09/14/2010 CHANGE ORDER #26

PROJECT NAME
CHILDREN'S HOSPITAL
OF ORANGE COUNTY
455 S. Main St.
Orange, CA 92868-3874

TOWER II

PENTHOUSE 3 MECHANICAL
PLAN AREA - H

M3.10H

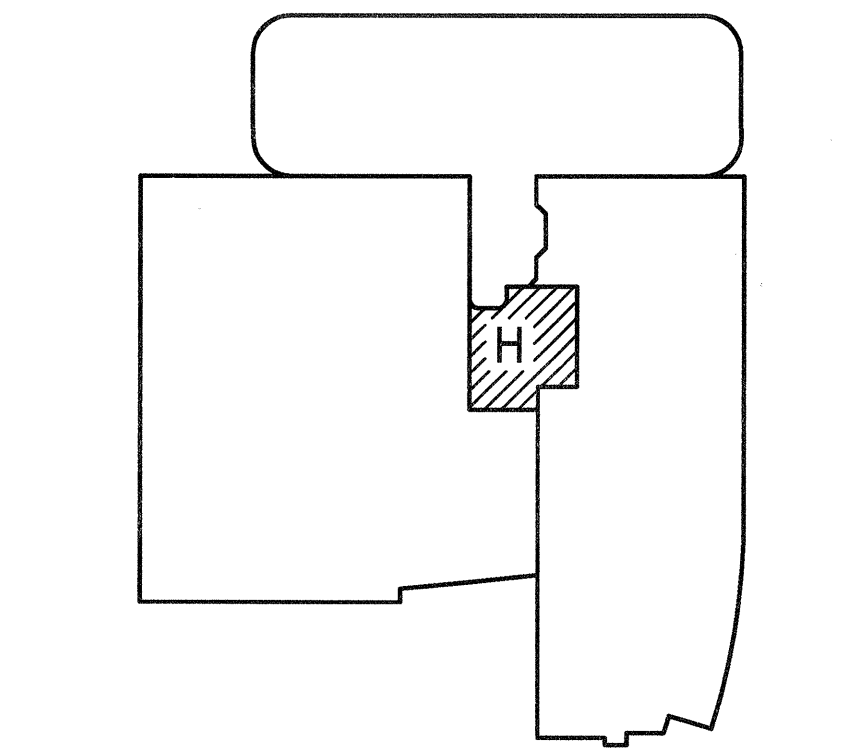
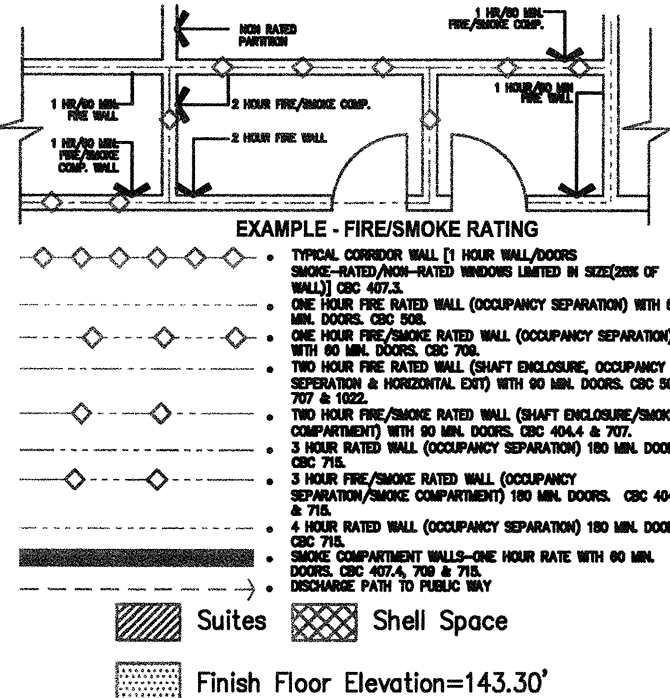
RFI 2585
Pad to move 6" to
north and pad
height goes from
24" to 6"

RFI #4360.1

RFI #5037
RWG to be changed to
36" wide x 30" high.

RFI 1726
